UNITED STATES PATENT AND TRADEMARK OFFICE

APPLICATION NO.	FILING DATE	FIRST NAMED INVENTOR	ATTORNEY DOCKET NO.	CONFIRMATION NO.
10/661,585	09/15/2003	Dimitar Danev	028987.52515US	8044
23911	7590	02/10/2005	EXAMINER	
CROWELL & MORING LLP INTELLECTUAL PROPERTY GROUP P.O. BOX 14300 WASHINGTON, DC 20044-4300			GARCIA, ERNESTO	
			ART UNIT	PAPER NUMBER
			3679

Office Action Summary

Switzerland Patent, CH-444,414

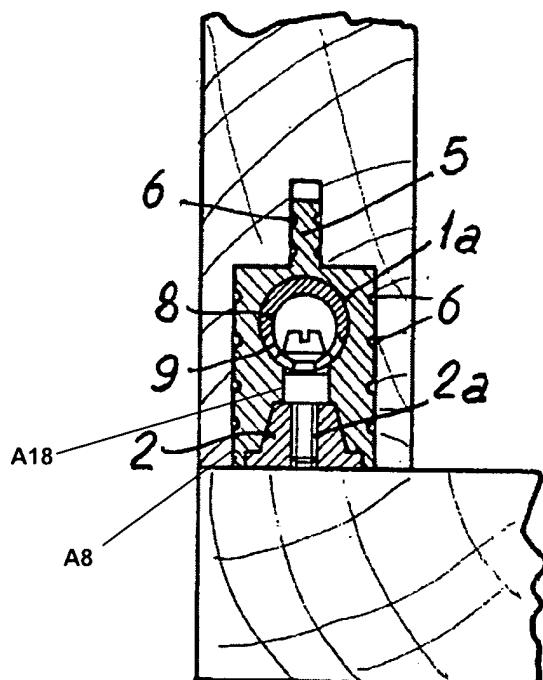
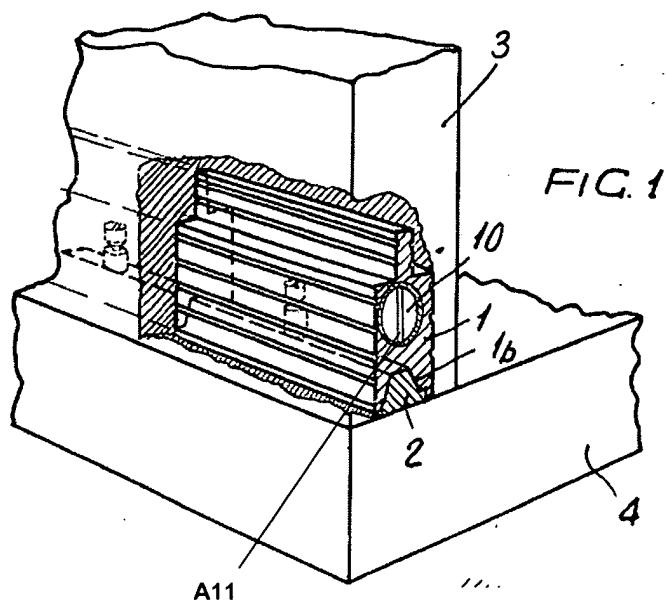
Claims 1, 2, 21, 22, 31, and 33-36 are rejected under 35 U.S.C. 102(b) as being anticipated by Switzerland patent, CH-444414 (see marked-up attachment).

Regarding claim 1, the Switzerland patent, discloses, in Figures 1-5, a releasable connection between two adjoining body shell part components, comprising a first component **4** and a second component **3**. The releasable connection comprises the first component **4**, the second component **3**, at least one base plate **2**, and a receiving device **1**. The base plate **2** is held in use in position on a first component **4** and has at least one projection pin **7**. The receiving device **1** is fastened to the second component **3** and has a rotatable slotted sleeve part **8**. An end-side profiled head section **7d** of the projection pin **7** is guidable through an opening **A8** of the second component **3**, an opening **A18** of the receiving device **1** and an opening **9** of the sleeve part **8**. Fastening of the first component **4** and the second component **3** with respect to one another takes place as a result of radial rotation of the sleeve part **8**.

Regarding claim 2, the releasable connection comprises at least two mutually spaced projection pins **7** arranged on the base plate **2** or on two separate base plates.

Regarding claims 21 and 22, at least one face-side end of the sleeve part **8** is closed by a wall **10**. A narrow longitudinal slot **A11** is provided at the wall **10**.

Regarding claim 31, the sleeve part **8** has an eccentric construction.
